PSNH PUBLIC SERVICE Company of New Hampshire SEABROOK STATION Engineering Office: 1671 Worcester Road Framingham, Massachusetts 01701 (617) - 872 - 8100

SBN-390 T.F. B7.1.2

- References: (a) Construction Permits CPPR-135 and CPPR-136, Docket Nos. 50-443 and 50-444
 - USNRC Memorandum, dated October 14, 1982, "Notice of Meeting Regarding Open Items in the Safety Review,"
 L. L. Wheeler to J. D. Kerrigan
 - (c) USNRC Memorandum, dated September 17, 1982, "Radiological Assessment Branch Site Tour of Seabrook Station," L. L. Wheeler to J. D. Kerrigan
- Subject: Response to Open Items (SRP 11.5.2, 12.3.2, 12.3.4; Effluent Treatment Systems Branch, Radiological Assessment Branch)

The following open items were discussed at the referenced meetings. A summary of each Open Item and our response is provided below:

FIGURE 12.3-19

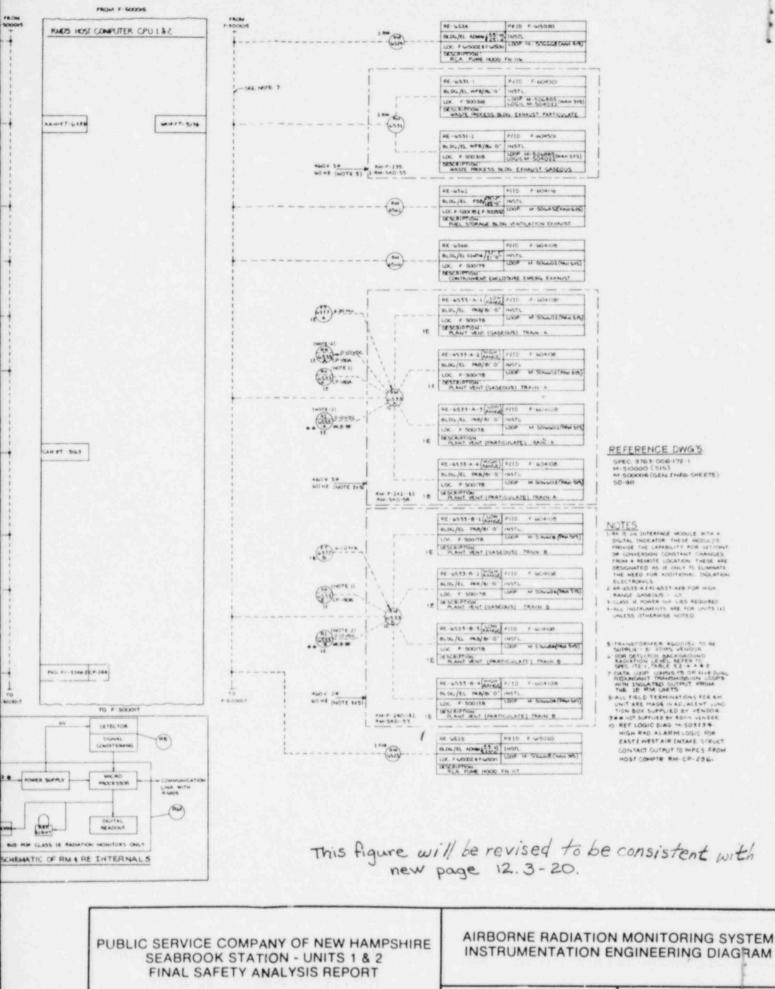
Summary: Airborne radioactivity monitoring ventilation monitors are installed downstream of filters so they can not monitor for implant airborne radioactivity.

Response: FSAR Section 12.3.4.2.b.2.(c) (FSAR Page 12.3-20) has been revised (see Attachment A) to include monitoring of Primary Auxiliary Building exhaust air upstream of filters.

These areas, which are potential sources of airborne activity, are maintained at a negative pressure with respect to surrounding areas, and have their own ventilation exhaust ducting, filters, and fans which direct the exhaust air to the plant vent. A continuous each of the two air sample is removed from the ducting downstream of the ducts on the inlet filters and monitored for particulate and gaseous activity. The sample is returned to the ventilation exhaust line, again, downstream of the filters. Indication and alarm is available locally and in the main control room for both units. An alarm indication on these monitors would trigger a radiological evaluation within the areas served by these monitored ventilation lines. The evaluation would be performed by station HP personnel using portable. Survey and/or air sampling equipment, as necessary, to 12.3-20locate the source of the ejevated ventilation line indication,
